Access Compliance Report

Public Rights-of-Way

Intersection ID: 28662	Main Street: MEADOWMONT_DR	Cross Street: MEADOWMONT_VIEW_DR	Location: SE
ADA ID: 92C4961E0D62	Ramp Type: PerpDiag	Initial Pass/Fail: Fail	Overall Compliance: No
Severity Score: 12.5			
Codes/Mitigation Info/Possible Solution		Field Measurements/Component Compliance

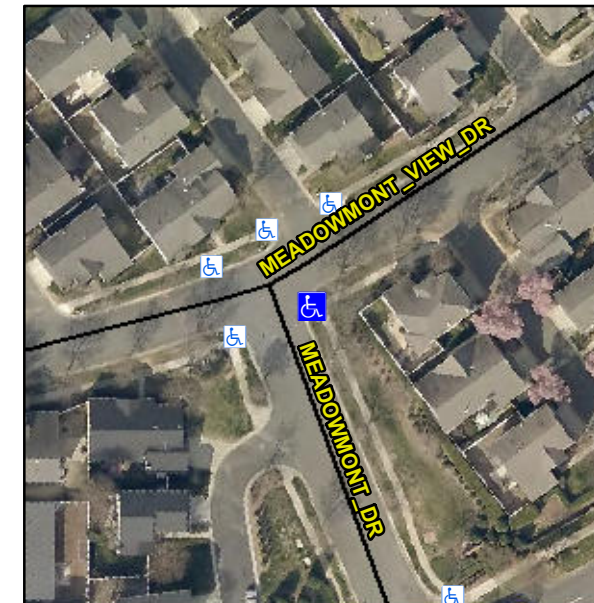
R304.2.2

Compliance	Description	Data	Compliance	Description	Data
N/A	Ramp Length (in)	71.0	No	Ramp Slope (%)	9.4
Yes	Ramp Width (in)	48.0	Yes	Ramp XSlope (%)	0.2
N/A	Flare Type LT	N/A	N/A	Flare Type RT	N/A
N/A	Flare Slope LT (%)	N/A	N/A	Flare Slope RT (%)	N/A
N/A	Flare Traversable LT?	N/A	N/A	Flare Traversable RT?	N/A
N/A	Landing Length (in)	N/A	N/A	DWS Provided?	N/A
N/A	Landing Width (in)	N/A	N/A	DWS Contrast?	N/A
N/A	Landing Slope (%)	N/A	N/A	DWS Length (in)	N/A
N/A	Landing X Slope (%)	N/A	N/A	DWS Full Width?	N/A
N/A	Landing Curb? (Y/N)	N/A	N/A	DWS Offset (in)	N/A
N/A	Shared Landing?	N/A			
N/A	Gutter Ponding?	N/A	N/A	Gutter Slope (%)	N/A
N/A	Gutter Lip Ht (in)	N/A	N/A	Gutter X Slope (%)	N/A
N/A	Painted X Walk1?	No	N/A	Painted X Walk2?	No
	X Walk 1 Direction	To N		X Walk 2 Direction	To W
N/A	X Walk 1 Width (in)	N/A	N/A	X Walk 2 Width (in)	N/A
	X Walk 1 Slope (%)	7.8		X Walk 2 Slope (%)	1.7
	X Walk 1 X Slope (%)	1.3		X Walk 2 X Slope (%)	3.3

Remove & Replace Curb Ramp With Two New Directional Ramps or Equivalent.
